**APPLICATION FOR
SPECIAL PERMIT AND SITE PLAN APPROVAL
(Planning Board)
And
VARIANCES
(Zoning Board)
FOR
PERSONAL WIRELESS SERVICE FACILITY

SUPPLEMENT No. 1**

Applicant: Vertex Towers, LLC
Site Id: VT-MA-0019F
Property Address: 26 Martin Road, Buckland, MA 01338
Tax Assessors: 8-0-60 (facility)
8-0-60.1 (access)
Property Owner: Amos M. Franceschelli and Christopher Franceschelli
Date: May 13, 2022

Reference is made to the letter of the Buckland Planning Board dated April 21, 2022 with respect to the above referenced Application.

RF Existing & Combined VT-MA-0012A Coverage Without VT-MA-0019F@-95dBm

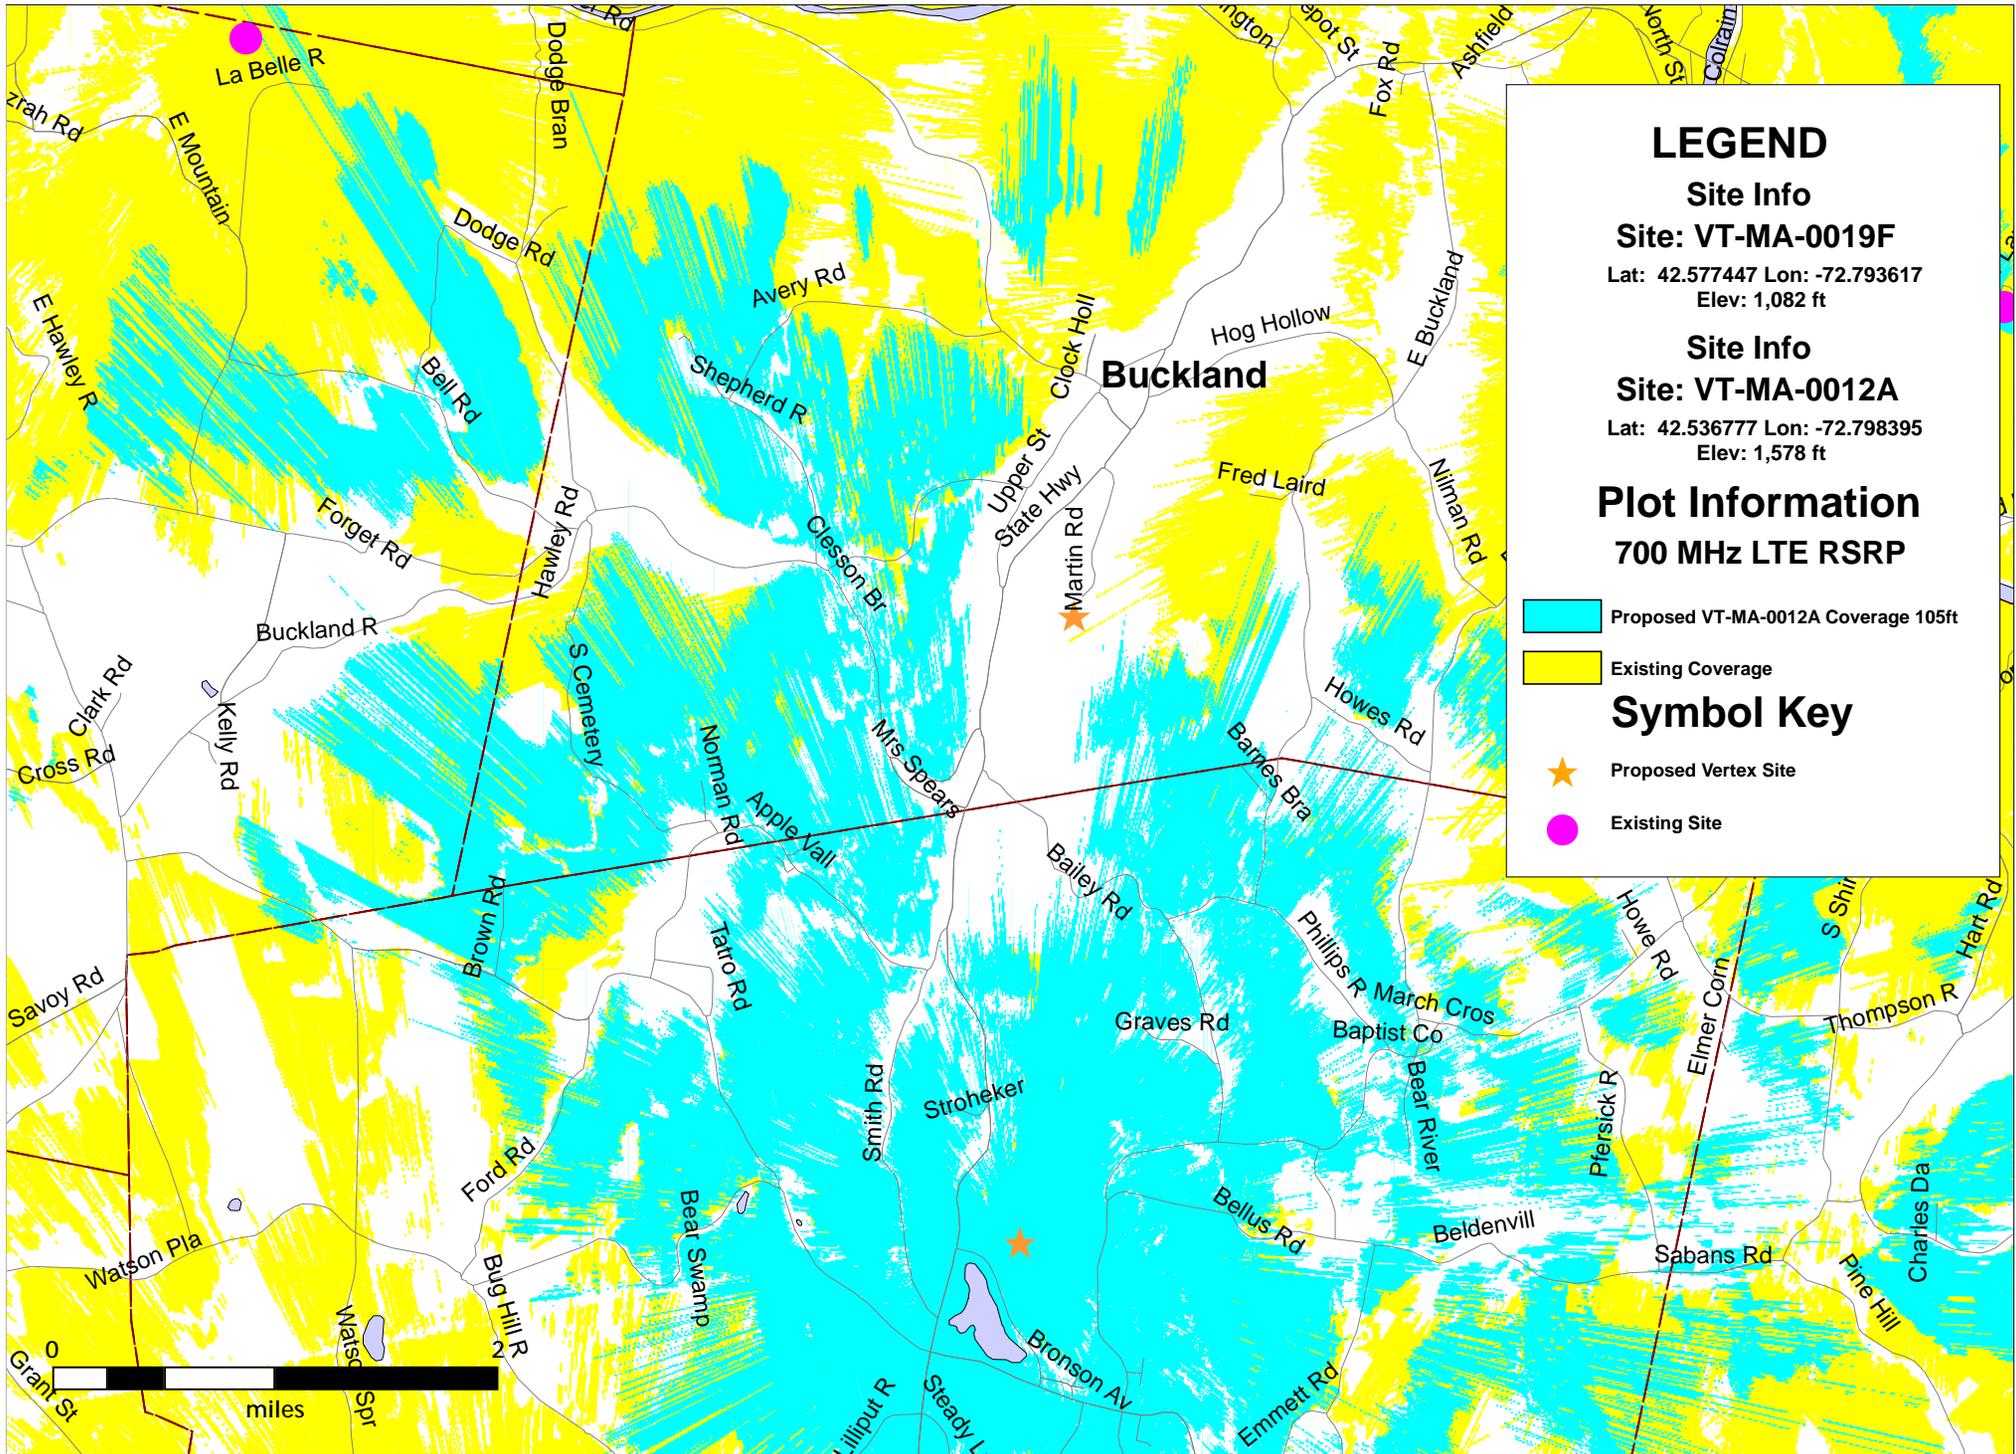
- 5. In Section 9, there are two maps titled “RF Existing & Combined VT-MA-0012A Coverage Without VT-MA-0019F@-95dBm” and “RF Existing & Combined VT-MA-0012A Coverage With VT-MA- 0019F@-95dBm” that each show “existing” and “proposed” in the same yellow color, and so it is impossible to see the difference*

TREE DOMINANT SPECIES PLAN
 SCALE: 1"=150' (22x34)
 1"=300' (11x17)

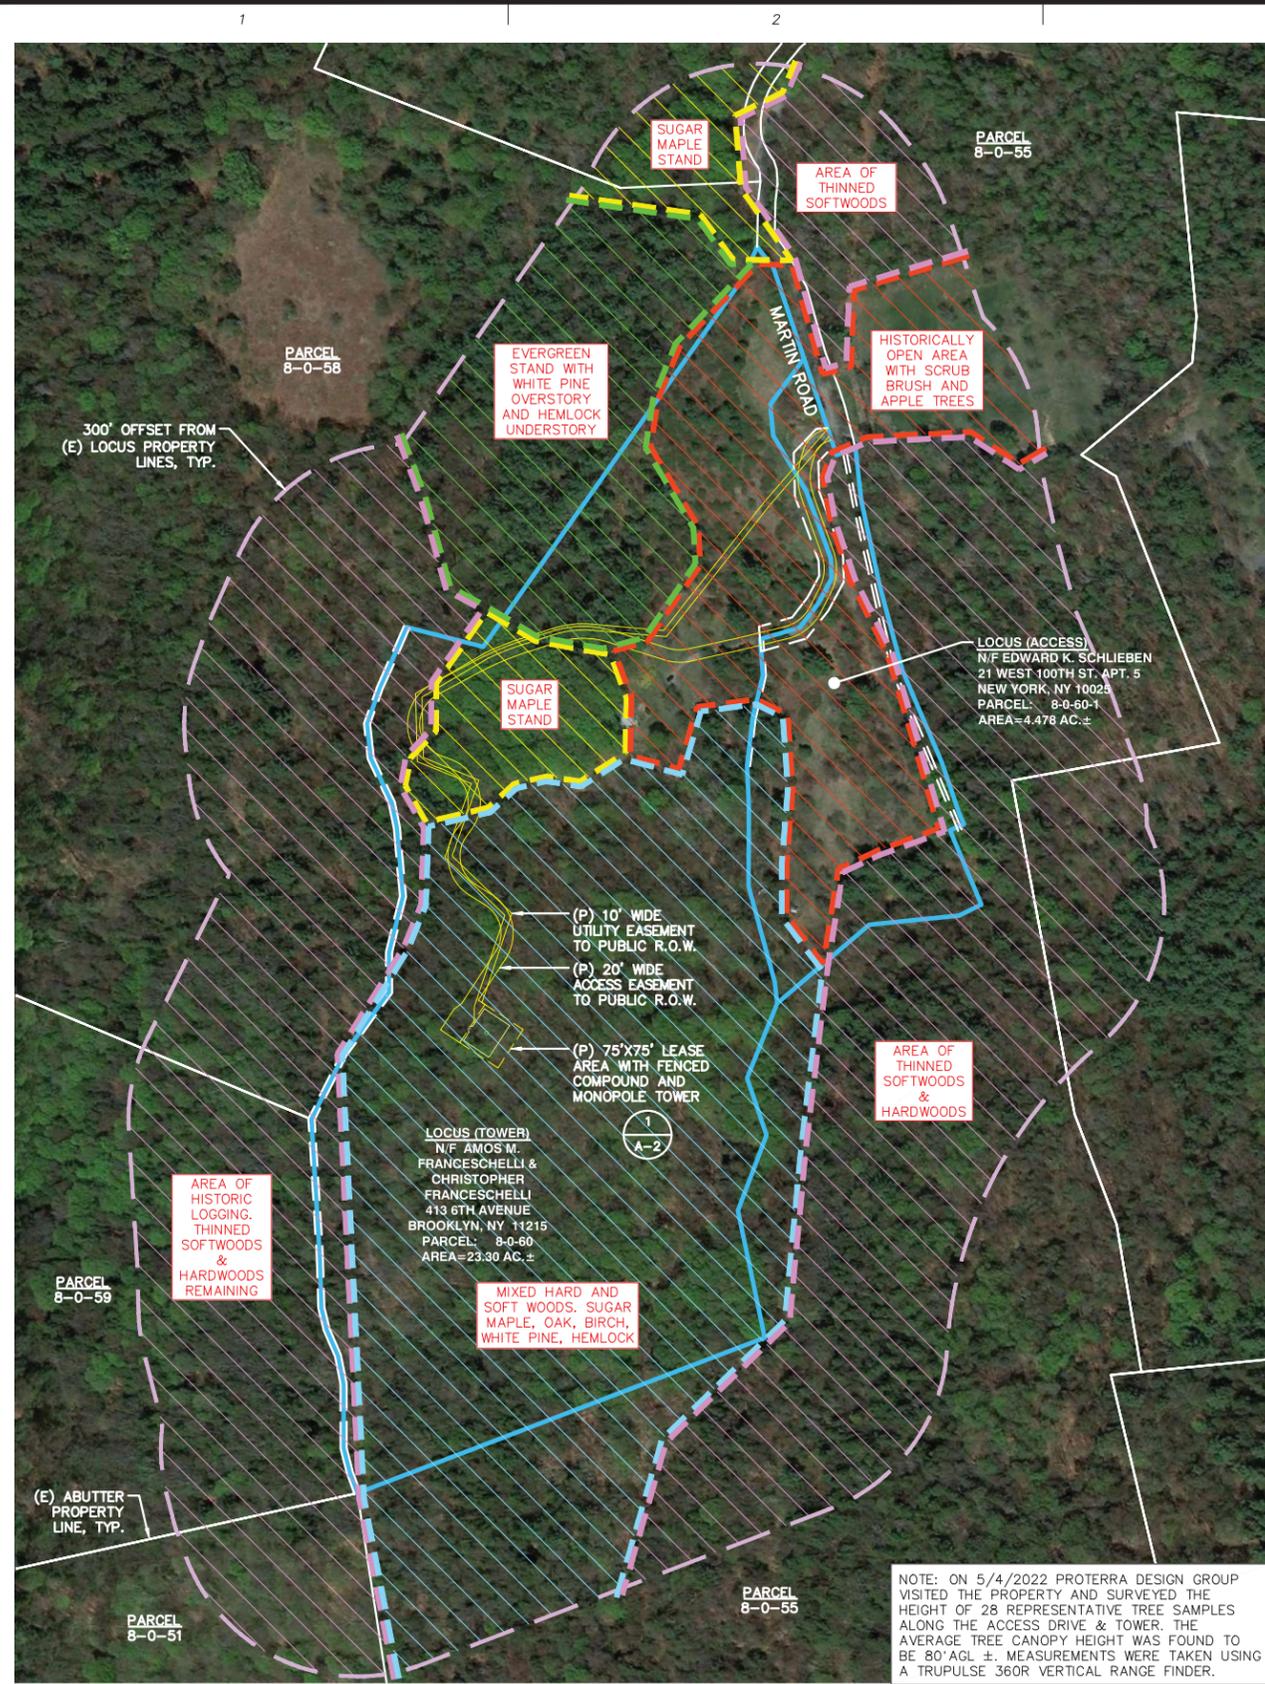
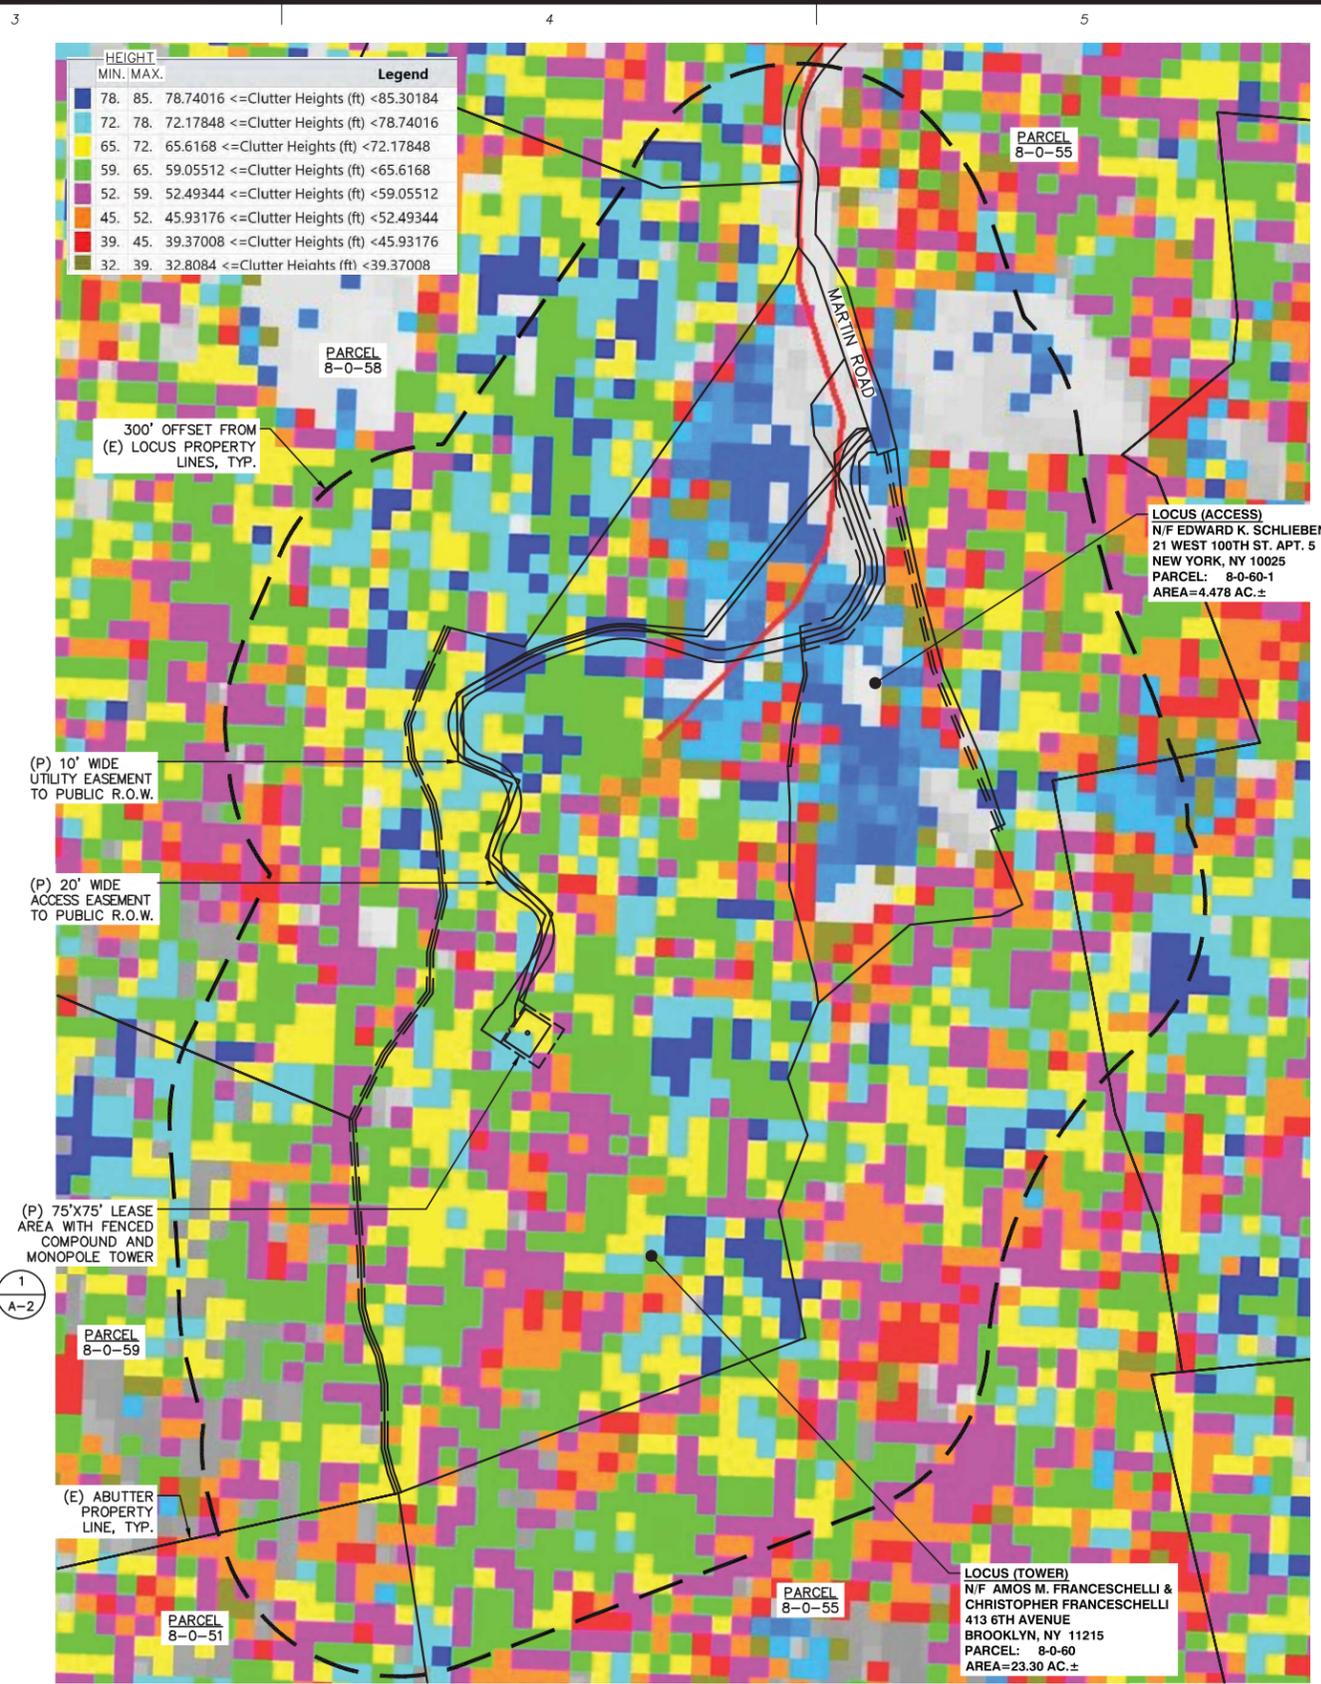
Included with this Response is Supplemental Plan Sheet SP-1 illustrating a tree canopy height mapping depicting tree canopy heights across the entire site and beyond. Additionally, civil engineers have taken a sampling of tree heights in the vicinity of the site, indicating an average tree height of 80', as noted on Supplemental Plan Sheet SP-1

*Please provide items (8), (9), and (10). In particular, the Planning Board needs additional detail on existing vegetation (measured by or available from a **verifiable source**) and proposed vegetation removal.*

Supplemental Plan Sheet SP-2 includes this information. Supplemental Plan Sheet SP-1 illustrates a tree canopy height mapping depicting canopy heights across the entire site and beyond, utilizing 'ATOLL' engineering software. In addition, the Notes on SP-1 indicate that a sampling of tree heights was taken in the vicinity of the site by a civil engineer indicating an average tree canopy height of 80'. All proposed changes to the existing property are shown on sheets A-2, And sheets P-1 through P-3 of the original submission.

NOTE: ON 5/4/2022 PROTERRA DESIGN GROUP VISITED THE PROPERTY AND SURVEYED THE HEIGHT OF 28 REPRESENTATIVE TREE SAMPLES ALONG THE ACCESS DRIVE & TOWER. THE AVERAGE TREE CANOPY HEIGHT WAS FOUND TO BE 80' AGL ±. MEASUREMENTS WERE TAKEN USING A TRUPULSE 360R VERTICAL RANGE FINDER.
